Planning & Zoning Board

1. App# 2026-0030; 755 S. Waggoner Road; Brad Southard for Havens Corner & Dixon, LLC; Variance

RE: Brad Southard of ACCi; 755 S. Waggoner Road: Variance Application

Date: February 11, 2026
To: Phoenix Buathier, Development Assistant
From: Mitchell Yake, City Engineer
Subject: 755 S. Waggoner Road Variance – Staff Report
Copies: Eric Meyer, Director of Development

SITE & TRANSPORTATION PLAN

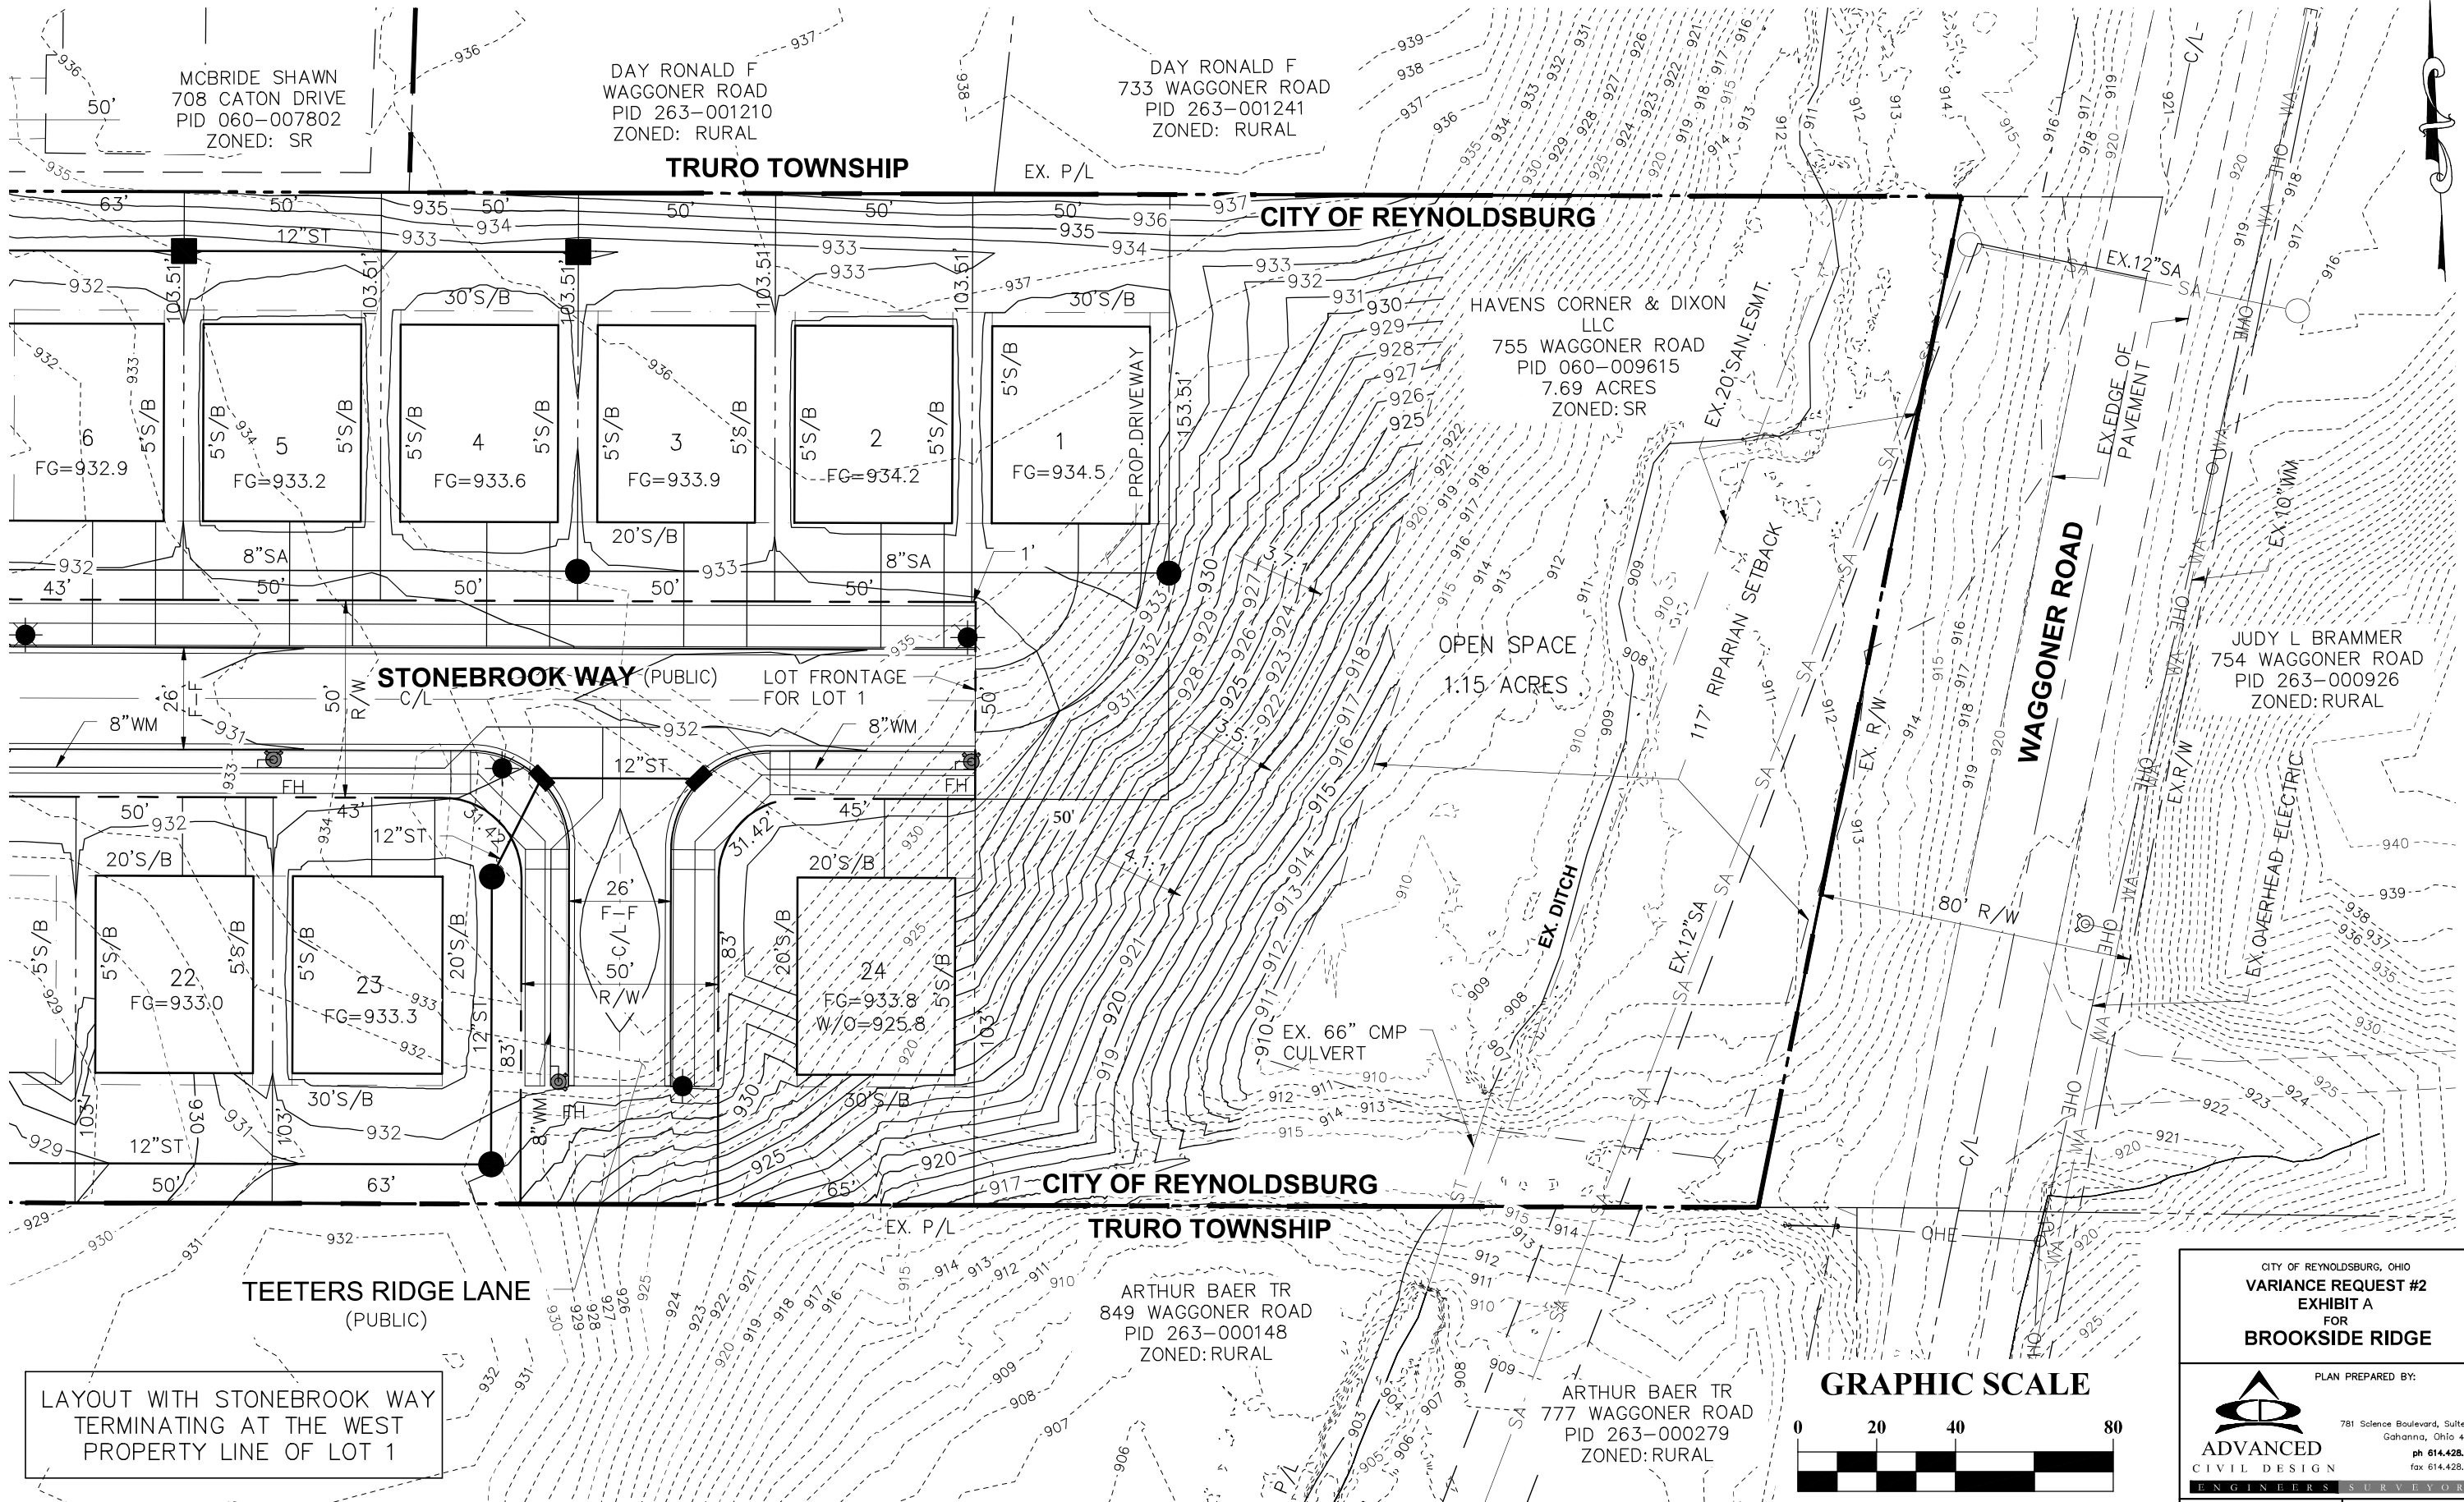
1. The project proposes to construct 24 single-family dwelling units and indicates that the site can be accessed via Amelia Drive (extending west from Waggoner Road) to the proposed extension of Caton Drive, which then terminates at Stonebrook Way to the south. Based on the anticipated traffic demand, this roadway network appears to provide adequate access for the development.

2. A proposed street, Teeters Ridge Lane, is located south of Stonebrook Way and is planned as a future extension into the adjacent Truro Township property, which is expected to be annexed into the City. All three proposed streets—Caton Drive, Stonebrook Way, and Teeters Ridge Lane—are designed with a 26-foot pavement width and a 50-foot right-of-way, both of which meet City standards.

3. Sidewalks are proposed on both sides of Caton Drive, Stonebrook Way, and Teeters Ridge Lane, each with a width of 5 feet, which is consistent with City requirements.

7. The project intends to construct a retention basin on the west end of the project site which will collect all storm flows from the proposed project area. A 12-in storm pipe from the retention basin will convey all flow from the west side of the basin to the east edge of the 100-year floodplain (approximately 30 feet west of the basin), where it will eventually feed into the French Run stream. A comment was made to provide details for the retention basin in the future PGU along with a stormwater management report.

9. Code Section 1103.17(III) Lot Dimensions-Lot depth (Code requires a minimum lot depth of 100 feet) - The Applicant requests a Variance for Lot #1 to reduce the required lot depth by 50 feet, thereby permitting a Lot depth of 50 feet. The Applicant contends that this Variance is necessary due to site-specific constraints of the Lot and the street layout.

10. Code Section 1103.17(III) Setbacks-Front and rear yards (Code requires a minimum front yard setback of 20 feet and a minimum rear yard setback of 30 feet) - The Applicant requests a Variance for Lot #1 to reduce the front yard setback by 15 feet and the rear yard setback by 25 feet, thus permitting a 5 foot front and rear yard setback. The Applicant contends that the Variance is necessary due to the unique configuration of the Lot given Stonebrook Way terminates at the property line from the west.

11. Code Section 1111.15(F)(i) Subdivision Regulations-Lots and blocks (Code requires side lines of lots be approximately at right angles or radial to the street line) – The Applicant requests a Variance for Lot #1 for the same reasoning as in Item 10; the configuration of the Lot due to the fact that Stonebrook Way terminates at the lot from the west side. As a result, the layout of Lot #1 would not allow for a right-angle sideline or radial to the street since the Lot lines would not be parallel to a street given there would not be a street in front of the unit. The Applicant contends that the Variance would allow the Lot to be more consistent with the proposed development pattern and surrounding lots.

12. Code Section 1103.17(III)- Lot Dimensions-Lot frontage at the right-of-way line. (Code requires a minimum of 50 feet of lot frontage measured at the R/W line) - The Applicant requests a Variance for both Lots #13 and #14, to reduce the lot frontage to 37 feet and 36 feet (respectively) since both Lots are located at the curved bulb area of the cul-de-sac. Both Lots would otherwise comply with all other code requirements for lot development based on the Site Plan provided.

CITY OF REYNOLDSBURG, OHIO
VARIANCE REQUEST #2
EXHIBIT B
FOR
BROOKSIDE RIDGE

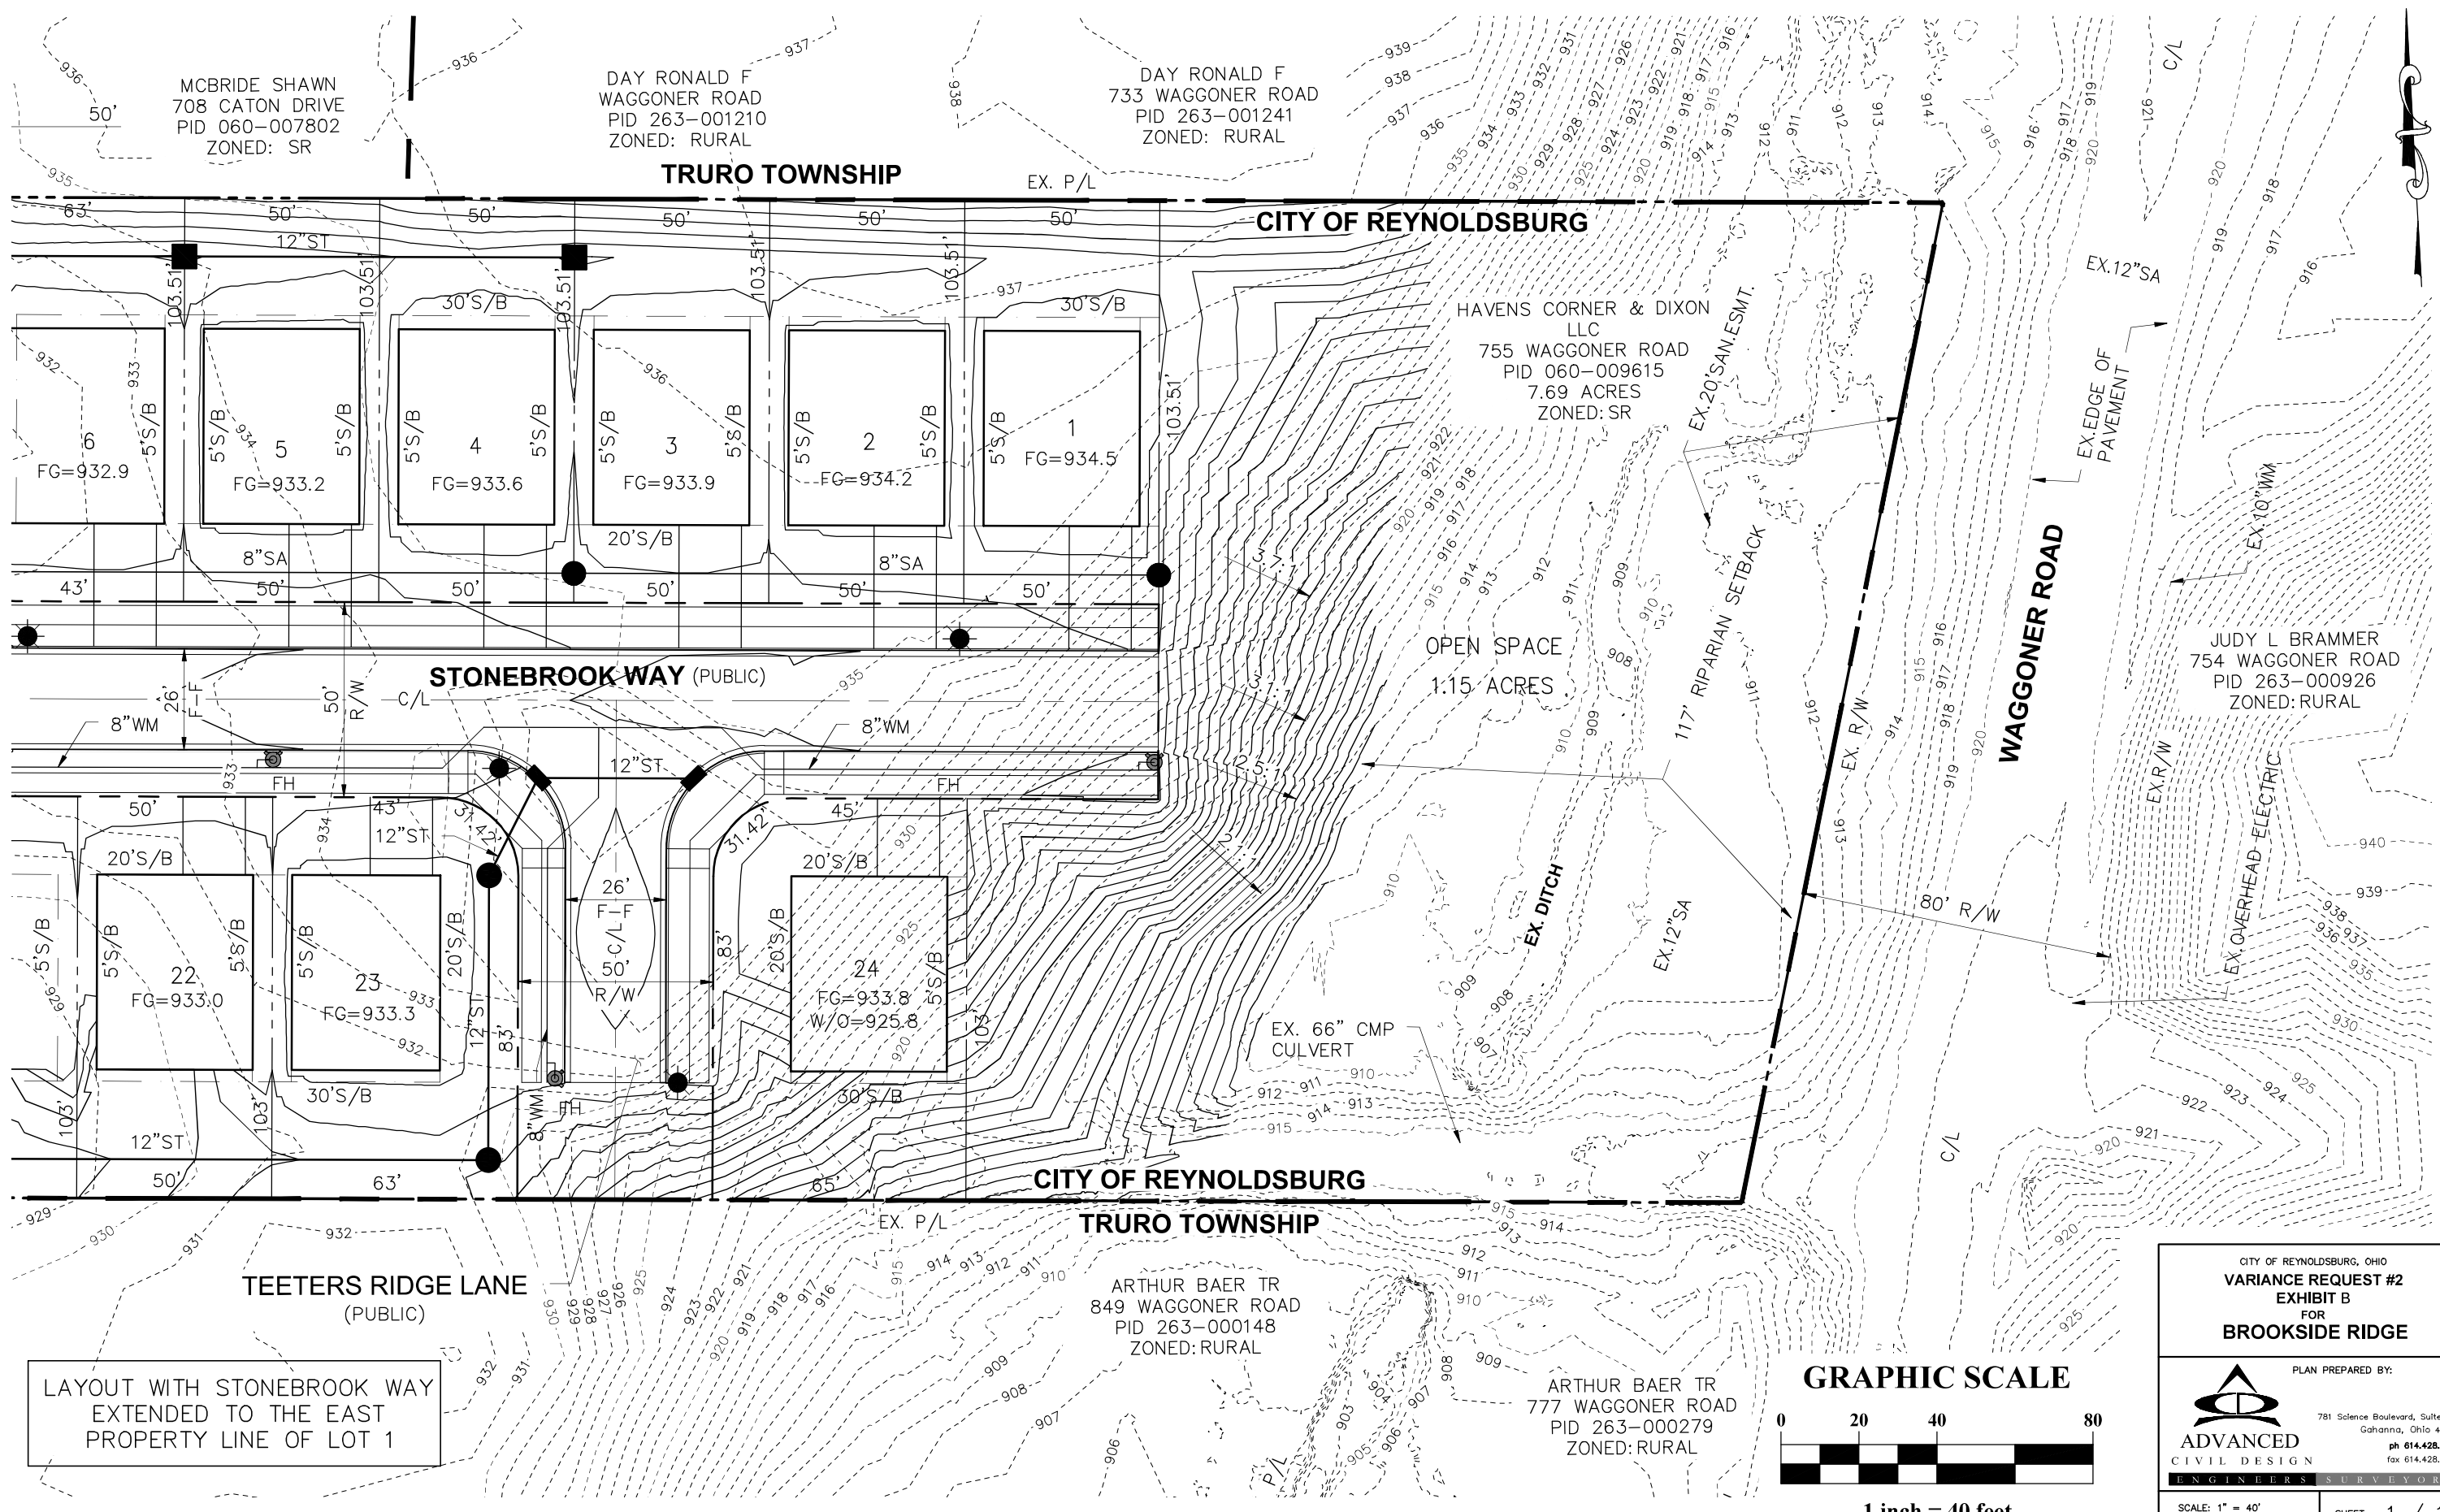
The applicant states for lot 1, that the variances are necessary due to the site-specific constraints, including topography, drainage features and the infeasibility of further street extension beyond the proposed right-of-way. The applicant provided an alternative layout for lot 1, showing that 3 requested variances for lot 1 would not be necessary if developed according to the alternative lot configuration for lot 1. Staff checked with the City Engineer, and the alternative image for lot 1 with the road extending is possible, just like the applicant’s engineered drawing shows. Staff believes developing the subdivision with the lot 1 alternative, which the applicant provided showing that lot 1 could still be developed according to the zoning code requirements with the topography and drainage features addressed, would not deprive the property owner of the reasonable use of land or structures. That the alternative site plan for lot 1 shows variances for lot 1 are not necessary.

With regards to lot 1, the proposed layout with the requested variances is necessary. However, the applicant did show an alternative layout where the lot depth variance request, the front and rear yard variance request, and the right angle at a public street variance request would not be necessary. In showing this alternative, staff is of the opinion that the applicant can meet the zoning code regulations without the requested variances.

The applicant with regards to Lot 1, does not explain why the road extension on the alternate site plan is not possible, clearly showing on their alternate plan that it is. Staff is of the opinion that the proposed site plan for lot 1 is self-created, since the lot could exist meeting the zoning code regulations, in the alternate site plan proposed. The applicant also does not address how the proposed lot 1 is necessary, or the design layout is not self-created.

The applicant is also requesting 3 variances in regards to lot 1. The applicant is requesting to reduce the required lot depth from 100 feet to 50 feet. To reduce the required front building setback from 20 feet to 5 feet, along with reducing the required rear building setback from 30 feet to 5 feet. Finally, the applicant is requesting a recommendation for relief from the required subdivision standards, which require side lines of the lot to be at a right angle or radial to the street line where frontage on a primary street is involved. The applicant states for lot 1, that the variances are necessary due to the site-specific constraints, including topography, drainage features and the infeasibility of further street extension beyond the proposed right-of-way. The applicant provided an alternative layout for lot 1, showing that the 3 requested variances for lot 1 would not be necessary if developed according to the alternative lot configuration for lot 1. The applicant's engineering drawings show that the street could be developed in a manner that would allow lot 1 to meet the zoning code requirements that the variances are requested for. Staff believes developing the subdivision with the lot 1 alternative, clearly shows that lot 1 could still be developed meeting the zoning code requirements with the topography and drainage feature hardship arguments addressed. That the alternative site plan proposed would not deprive the property owner of the reasonable use of land or structures. Staff is also of the opinion that granting additional variances for lot 1 to avoid additional grading or to need a retention wall due to not wanting to meet the alternative option shown for lot 1 by the applicant, would be a matter of convenience. That the alternative image for lot 1 shows that the requested variances for lot 1 are not necessary, therefore they should not be granted.
